SERVICE BULLETIN 28

SUBJECT: FITTING OF VARIOUS GLASAIR I PARTS TO GLASAIR II FUSELAGE

APPLICATION: BUILDER OPTION

FIGURE (1)

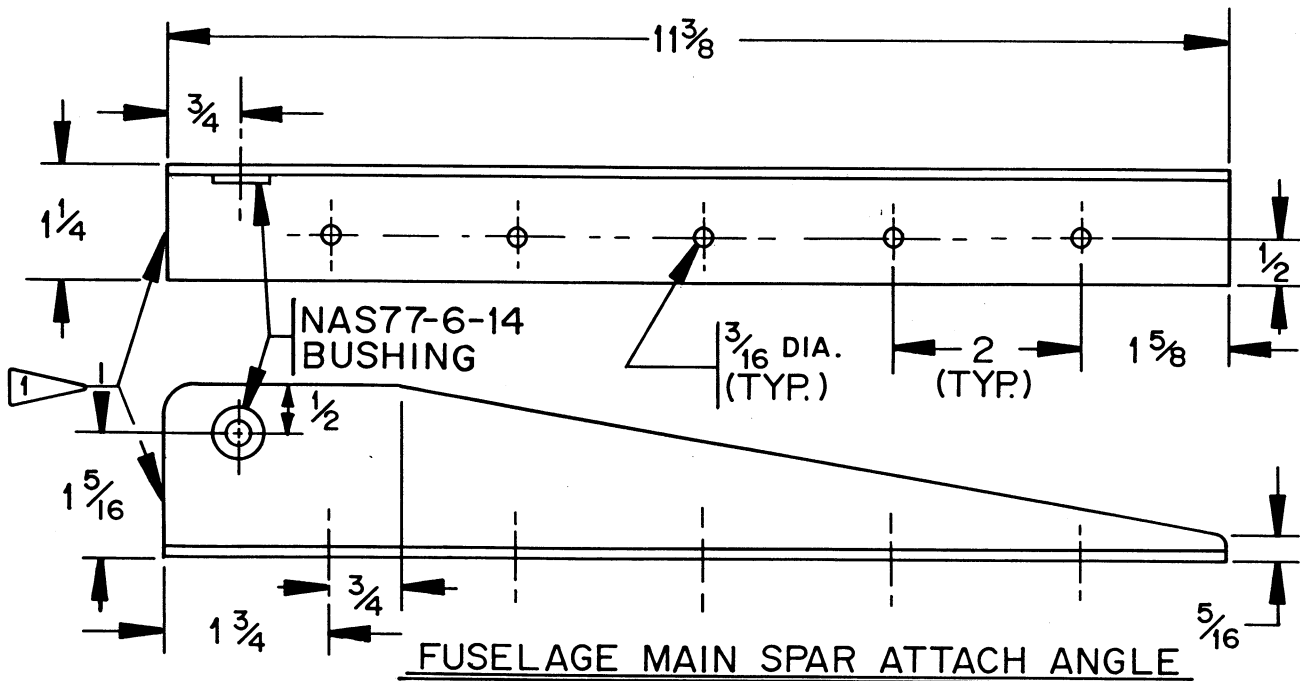
When using a Glasair I wing with a Glasair II fuselage, wider fuselage main spar attach angles must be fabricated, as shown in FIGURE (1), from material supplied in the upgrade kit. Use these angles when mating the wing to the fuselage, as described in the Wing to Fuselage Installation subdivision of the Final Assembly section of your original Glasair Instruction Manual.

Fabricate the fuselage main spar attach angles from 2" x 1-1/4" x 1/8" 2024-T3 aluminum angle, as shown in FIGURE (1).

NOTE: Make (4) fuselage main spar attach angles: (2) identically alike and (2) the exact mirror image of the first two.

To drill the holes for the NAS77-6-14 bushings, start with a 1/8" pilot hole and then step drill to enlarge the hole to size. For the final hole size, use a sharp drill bit just smaller than .500" and then ream the hole to size with a .500 reamer. The O.D. of the bushings are slightly larger than 1/2" (.5013"), so a press fit can be achieved if the holes are not drilled too large. We suggest using a drill press or a vise, if a small press is not available, to press the NAS77-6-14 bushings into the angles. Make sure the bushing collars are on the "outsides" of the angles, as shown.

FIGURE (2)

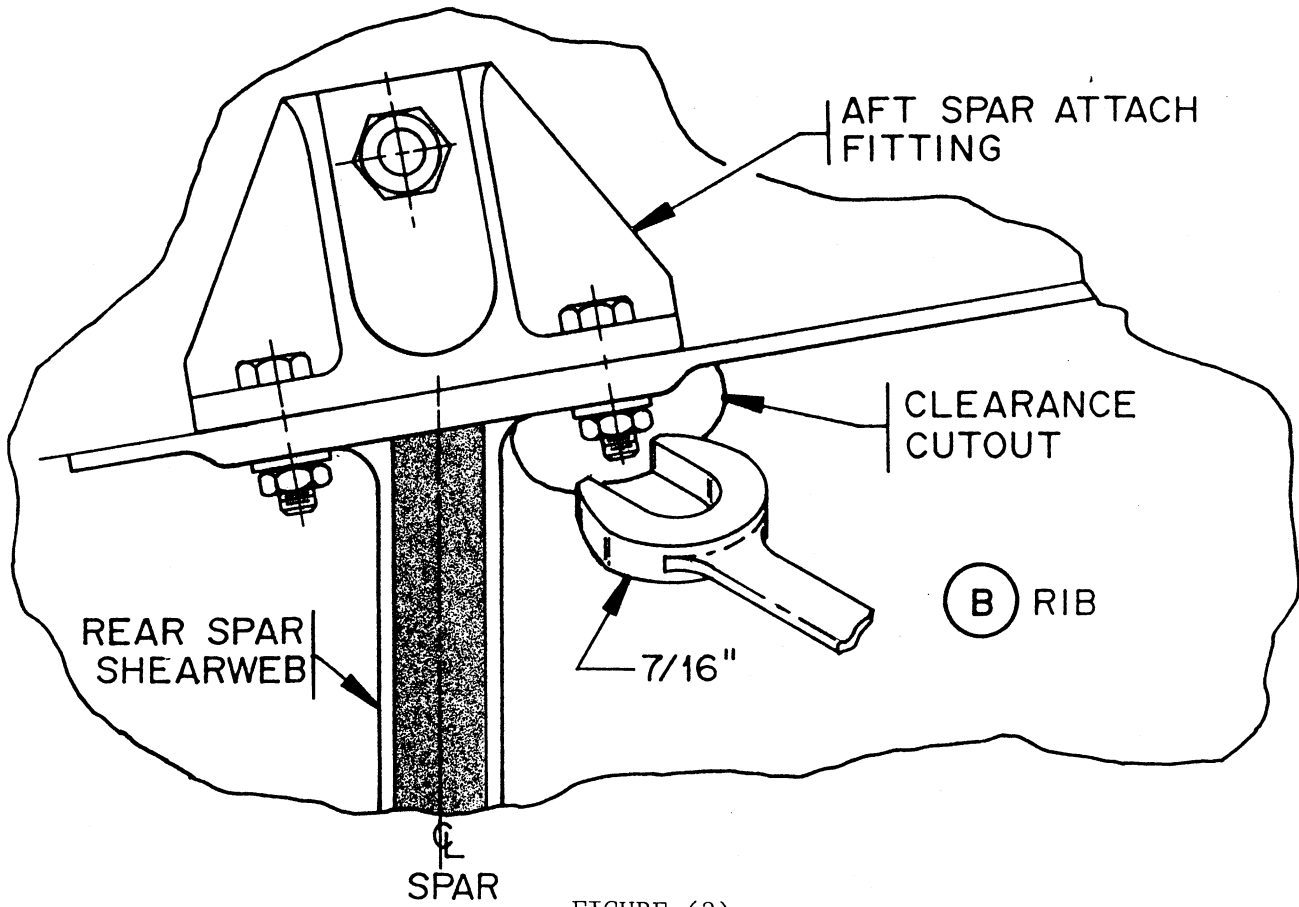
Because of the extra width of the Glasair II fuselage, the rear spar attach fittings must be moved outboard about 1-1/2" which places them very close to the inboard sides of the "B" ribs in the wing. If building an RG or a TD, the builder must carve out areas of the "B" ribs to provide clearance for the nuts that secure the attach fittings to the rear spar cap. Grind or carve away the minimum amount of "B" rib necessary to allow the AN364-428A nuts to fit the AN3-7A bolts. Allow sufficient clearance for an open end wrench to hold each nut, as shown in FIGURE (2). Make smooth radius corners on the clearance cutout.

NOTE: The "B" ribs on the FT model cannot be carved out in this area due to the unidirectional laminates in the upper edges of the ribs. If building an FT, install 3/16" aluminum spacers between the aft spar attach fittings and the insides of the fuselage panels to provide clearance from the "B" rib reinforcement cap laminates. This change requires longer bolts (AN4-15A instead of AN4-13A) for attaching the fuselage panels to the aft spar attach fittings.

FIGURE (3)

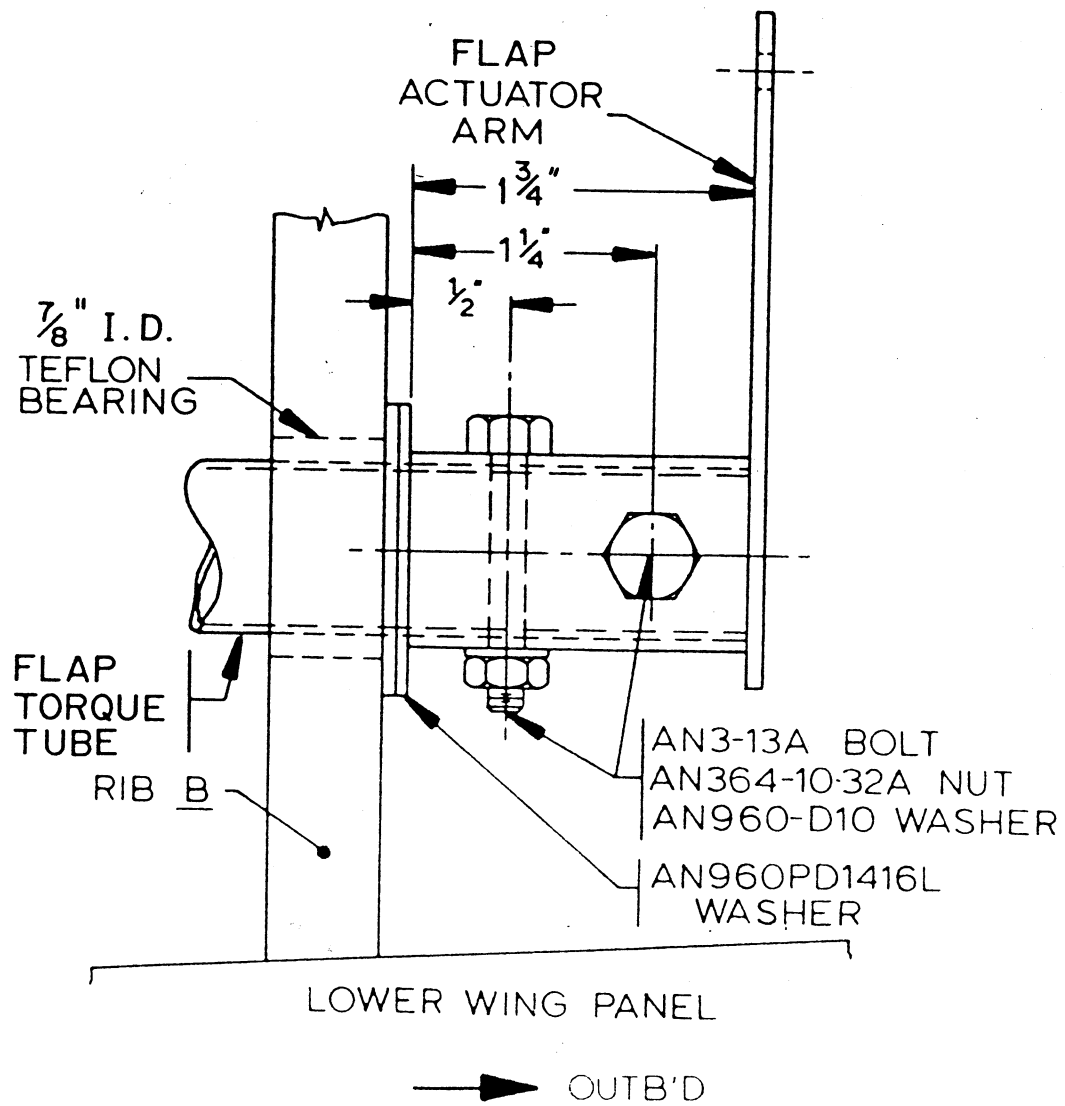
For FT and TD models of the Glasair I in which the wing ribs are already installed in their original locations, the flap actuator arm installation illustrated in FIGURE (3) must be used. This is the configuration of the flap linkage on the original Glasair I kits (by "original kits" we mean the earliest kits in which all the welding was left for the builder to complete), so, for these kits, no change in the flap linkage is required.

For later model Glasair I kits (kits for which all welding is completed during manufacture) that have already had the wing ribs installed, the flap actuator arms must be repositioned to align with the repositioned flap actuator fittings. For these airplanes, use a longer flap torque tube, install a 7/8" I.D. flanged teflon bearing in the B rib in place of the 1" I.D. bearing originally supplied, shorten the tubular part of the flap actuator arm to a 1-3/4" length, and assemble the components as shown in FIGURE (3). The longer flap torque tubes, 7/8" I.D. flanged teflon bearings, and the AN960PD1416L thrust washer shown in FIGURE (3) are available as part of the upgrade kit. Please call to request these parts if you fall into this category.
